Notice of Modification

Application Number:	MP 06_0228
Proponent:	Shoalhaven Starches Pty Ltd
Approval authority:	Minister for Planning
Project:	Shoalhaven Starches Expansion Project
Date of original approval:	29 January 2010
Modification:	MP 06_0228 MOD 2 – Operational and Energy Efficiency Improvements

APPENDIX 2A
SITE PLANS (MP 06_0228 MOD 2)

PPLA		PROJECT: PROPOSED MODIFICATIONS TO DISTILLERY
Peter Phillips		LANDSCAPE PLAN
Landscaping Architecture		DATE: 14/04/2012
PROJECT: PROPOSED MODIFICATIONS TO DISTILLERY		SCALE: 1:1000 AS
PROJECT: PROPOSED MODIFICATIONS TO DISTILLERY		DRAWN: Peter Phillips

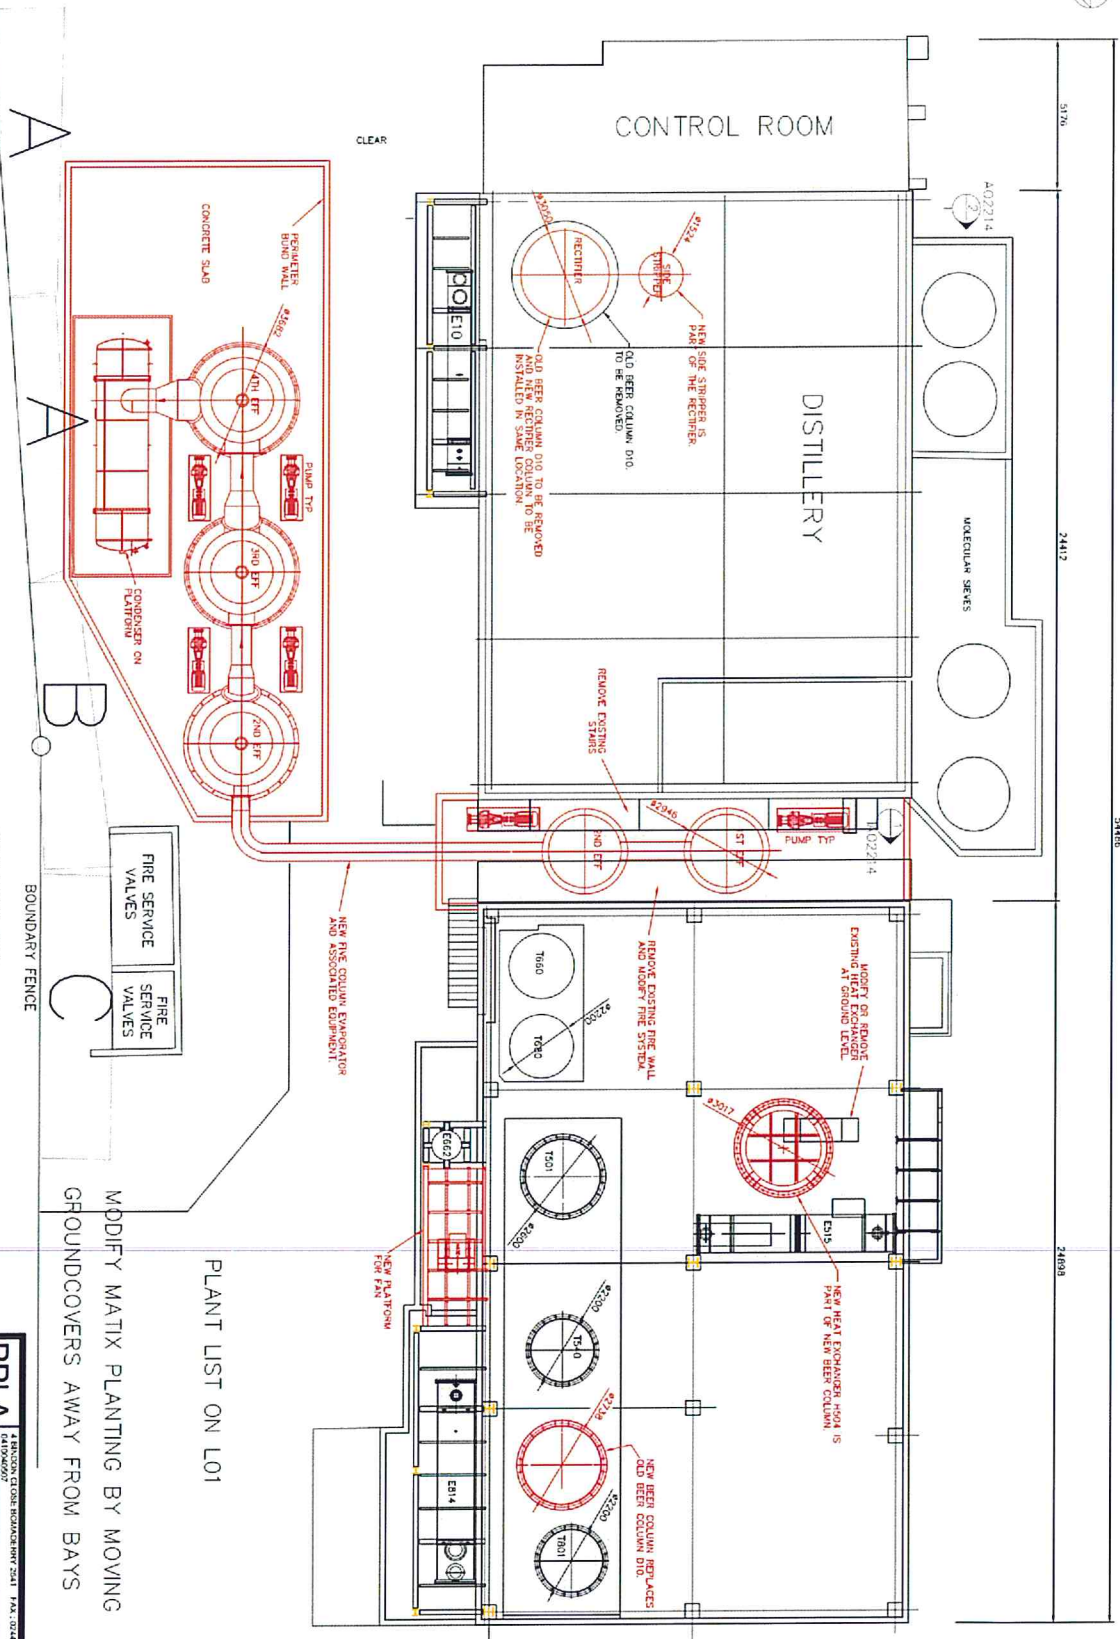
MODIFY MATX PLANTING BY MOVING
GROUNDCOVERS UNDER TREES

MODIFY MATX PLANTING BY MOVING
GROUNDCOVERS AWAY FROM BAYS
